Before the
FEDERAL COMMUNICATIONS COMMISSION
Washington, D.C. 20554

In the Matter of:
Establishment of Rules and Policies for the
Digital Audio Radio Satellite Service in the
2310-2360 MHz Frequency Band

Comments of Sirius Satellite Radio Inc.

December 14, 2001

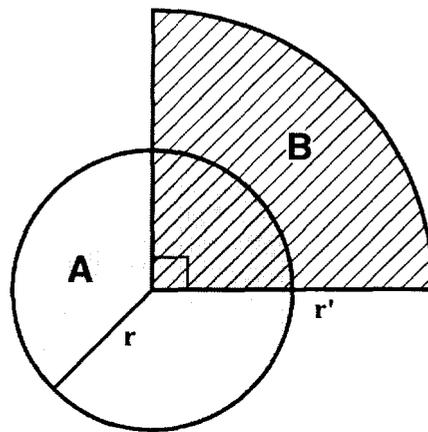
In fact, a 90-degree sectorized antenna with a power of 8 kW has the same reach and potential geographic area of interference as an omnidirectional antenna with a power of 2 kW and should be treated accordingly.²⁰ In the figure below, the circle “A” represents the area of potential interference generated by an omnidirectional repeater with an EIRP of 2 kW and the sector “B” represents the area of interference generated by a 90 degree sectorized repeater with an EIRP of 8 kW. Assuming the free space path loss proposed in the *Public Notice*,²¹ the areas of “A” and “B” are exactly the same.²²

²² Area “A” = πr^2 . ($r' = 2r$ (inverse square free space path loss)). Area “B” = $(1/4)\pi r'^2 = (1/4)\pi(2r)^2 = (1/4)\pi 4r^2 = \pi r^2$
